March 9, 2012

**RE: Review of EPA Investigation of Ground Water Contamination near Pavillion,  
Wyoming**

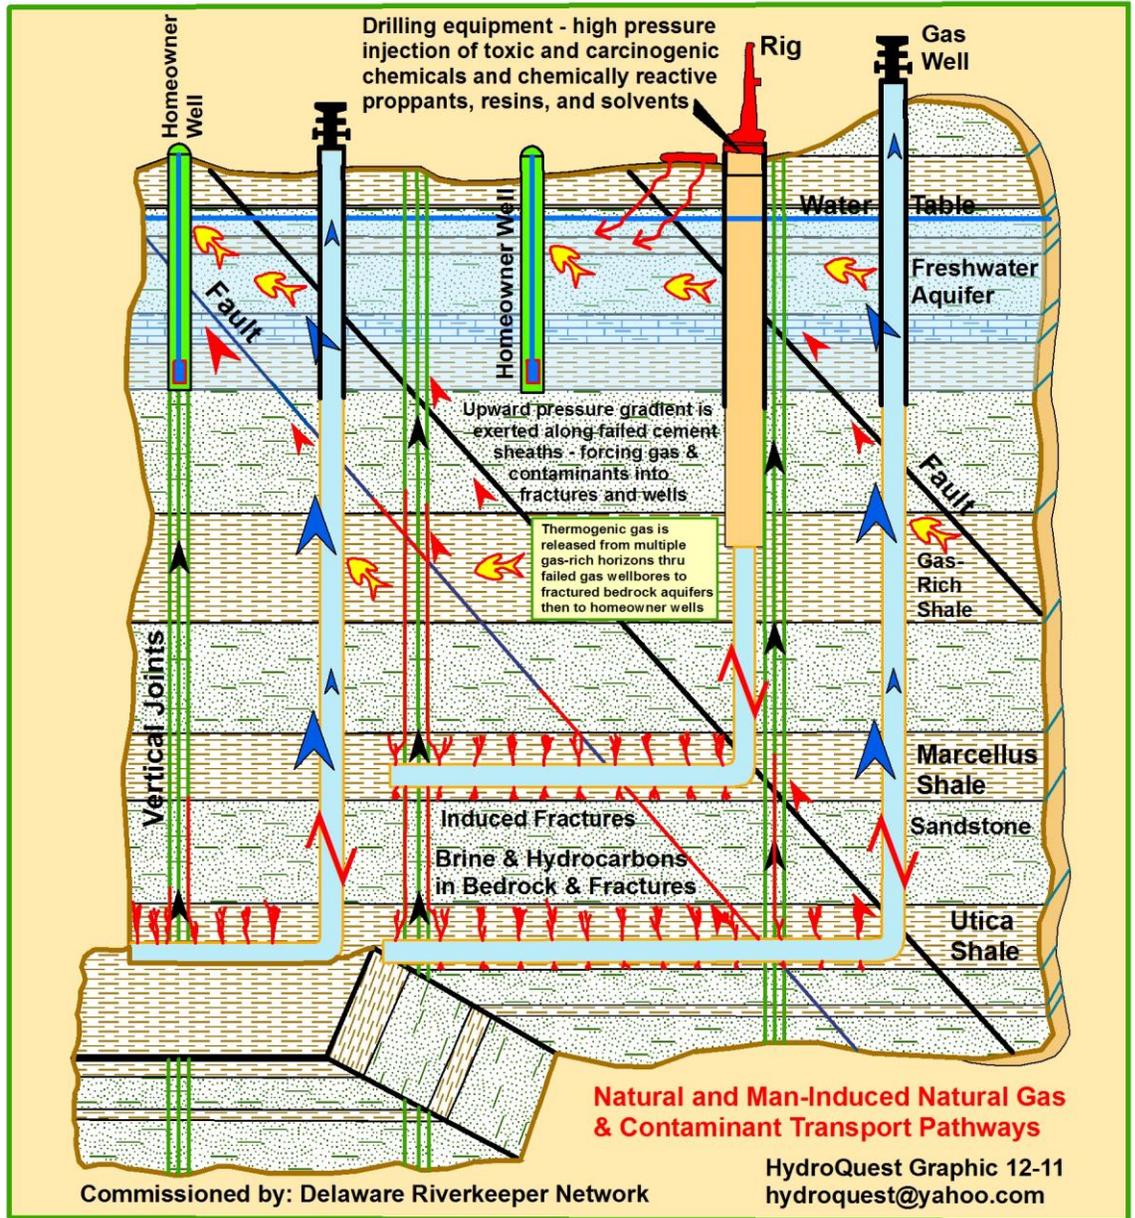
Other geologists have also documented fault presence in the Wind River Basin. Parker Gay (2002, Mapping geologic structure of basement and role of basements in hydrocarbon entrapment; Search and Discovery Article #40052) depicts a well known thrust-fold structure in the Wind River Basin as an example of asymmetric folds related to basement faults. These joints and faults (i.e., expansive planar features with high secondary permeability) provide extensive pathways for both upward migration of gas field contaminants and lateral, down gradient flow pathways in surficial aquifers (see figure below). The high density of fractures provides well interconnected groundwater flow pathways.

Thompson and others have documented hundreds of joints and faults in the Wind River Basin. All Thompson documented fractures, faults, and lineaments, plus any additional fractures not previously identified on aerial and satellite imagery should be plotted as an overlay on one of the gas and private well maps presented in the EPA study (e.g., Figure 5). Once plotted, relationships between contaminated wells and wells at future risk may become evident.
